Planning Commission Meeting 700 Doug Davis Drive Hapeville, Georgia 30354

October 8, 2019 AGENDA 6:00 pm

3.I.i. O Porsche Avenue Site Plan Review

RE: Site Plan Review – Porsche Avenue Service Center

FLOOR PLAN

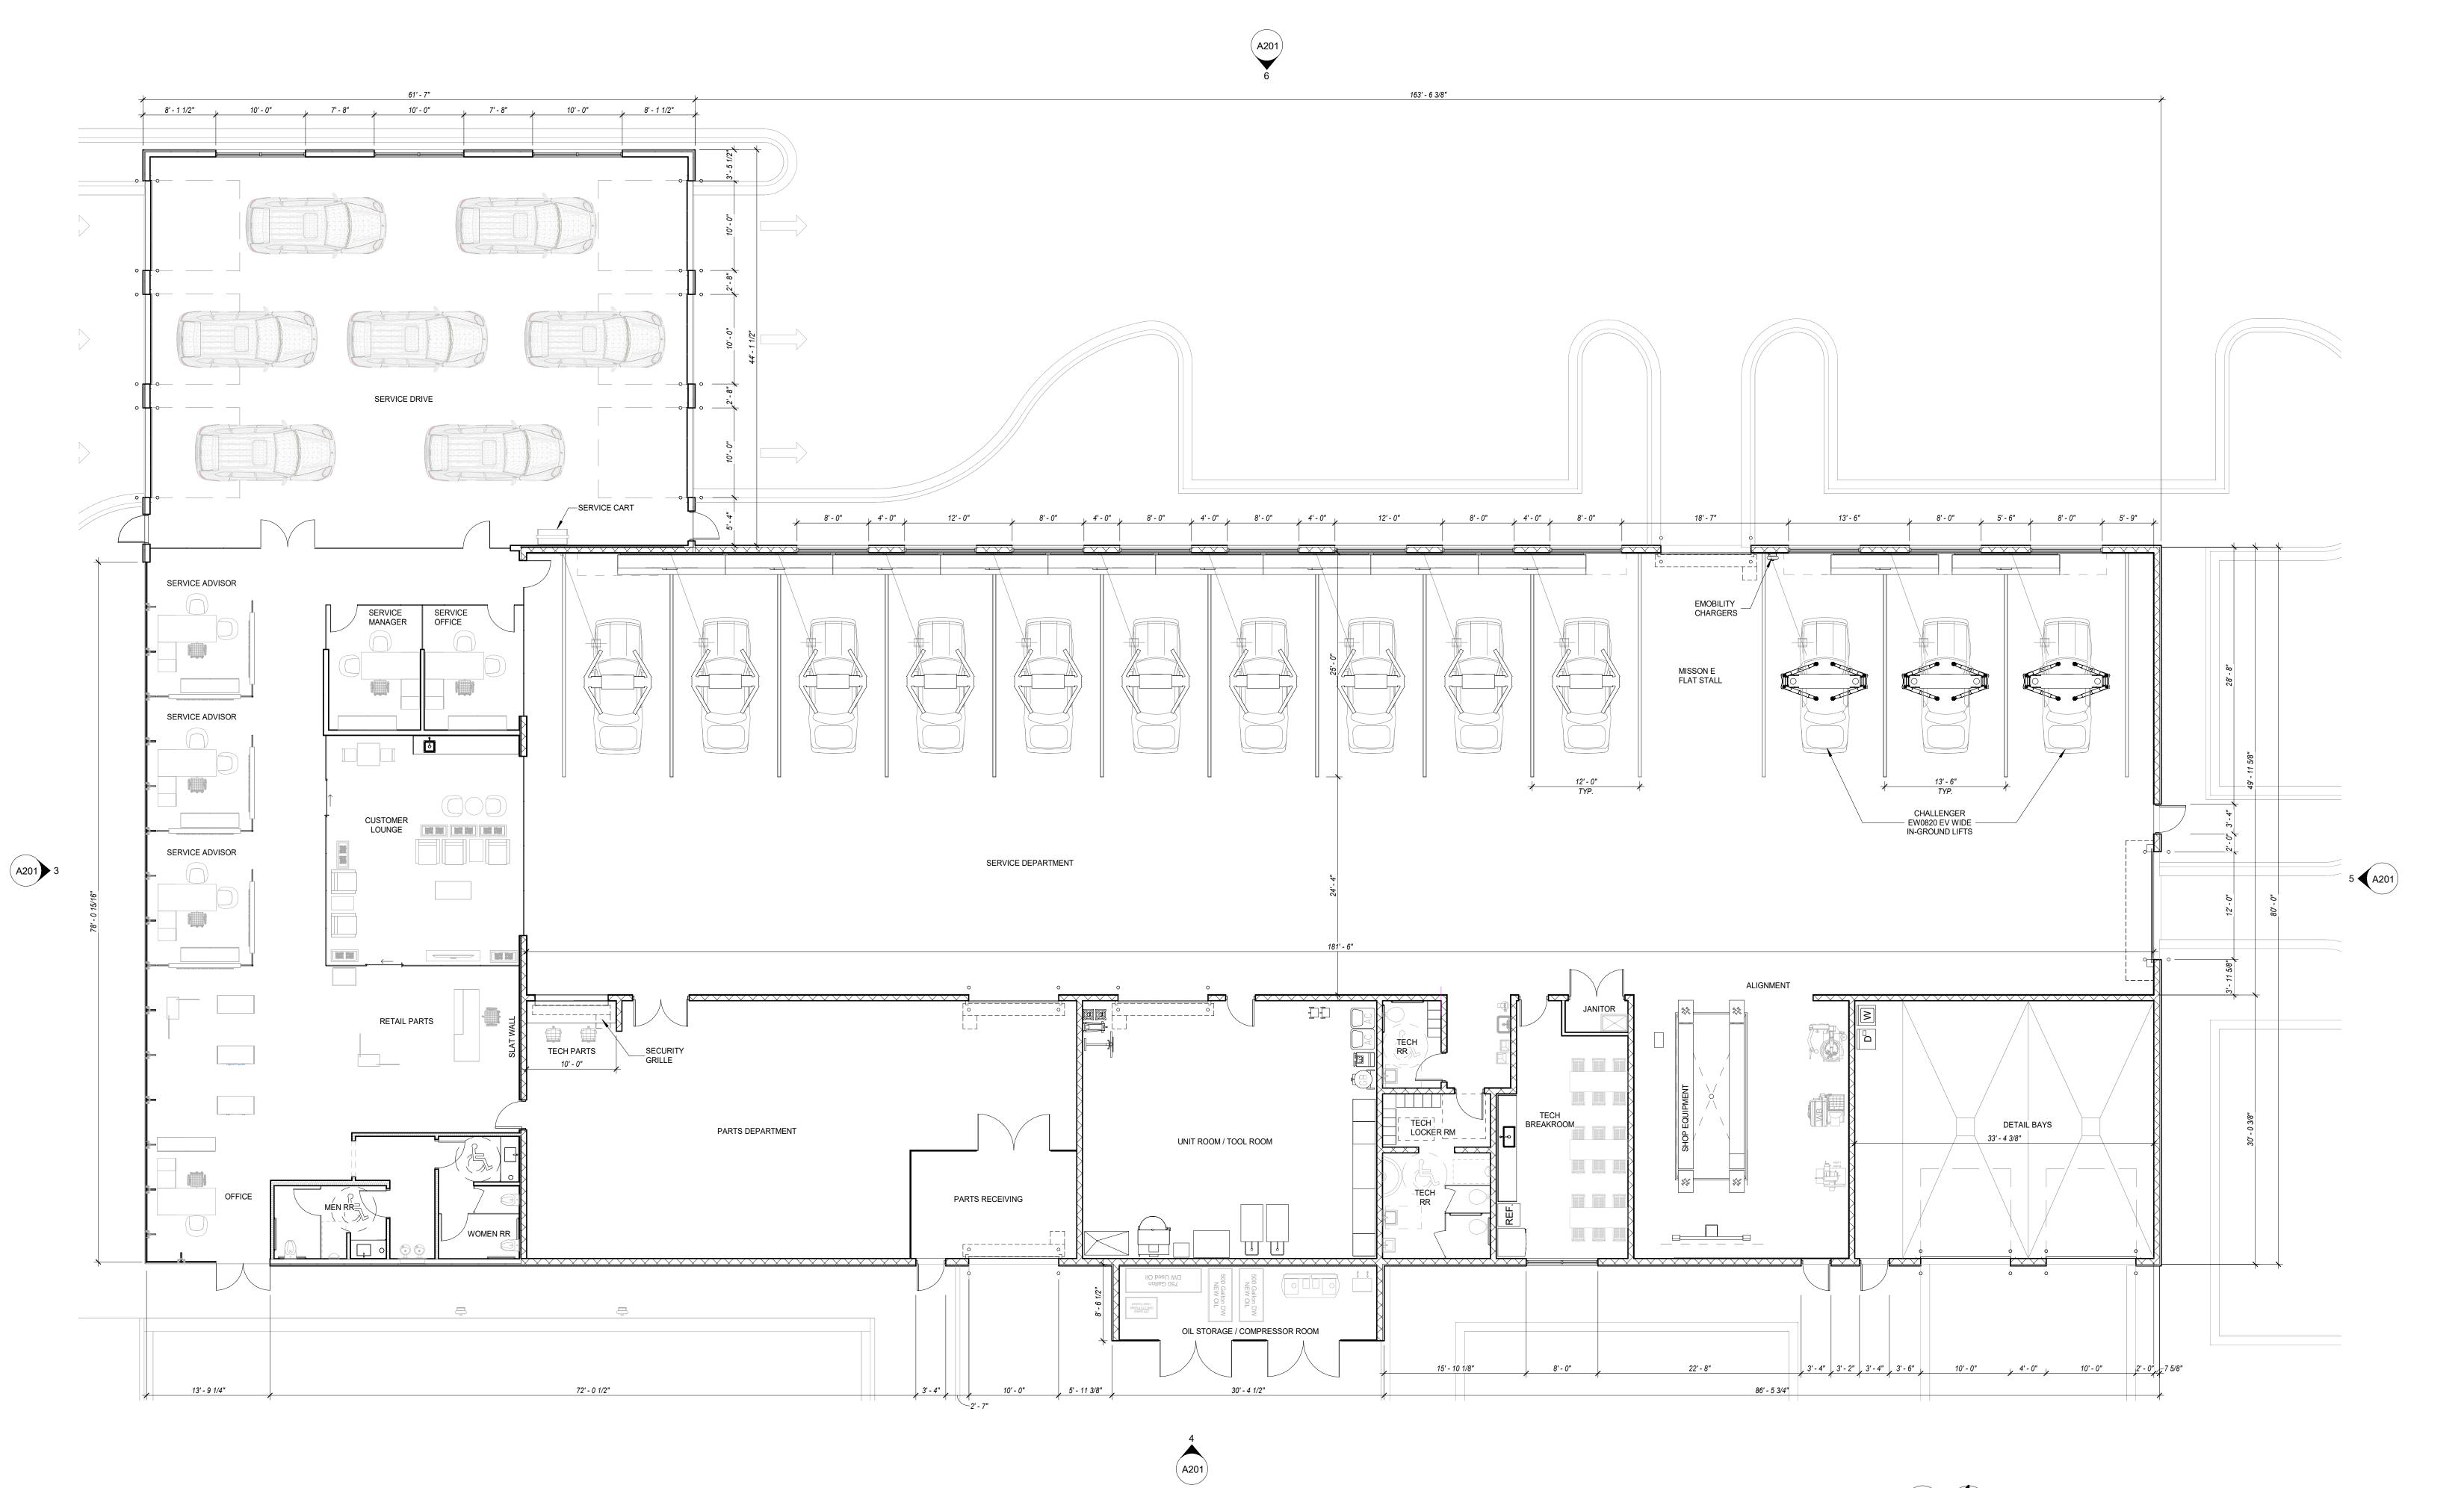
Commented [MS1]: Discrepancy in plans. Lower number on site plan, higher number on architectural drawings.

- Setbacks are not required in the B-P district for the main building.
- The structure will be 20' tall and have an area of 17,600 SF/20,815 SF. <u>Applicant should clarify the actual square footage.</u>

Commented [MS7]: Another discrepancy. Site plan 148/Architectural drawings 143.

Commented [MS12]: Based on 17,600 sf from site plan/20,815 from architectural drawings.
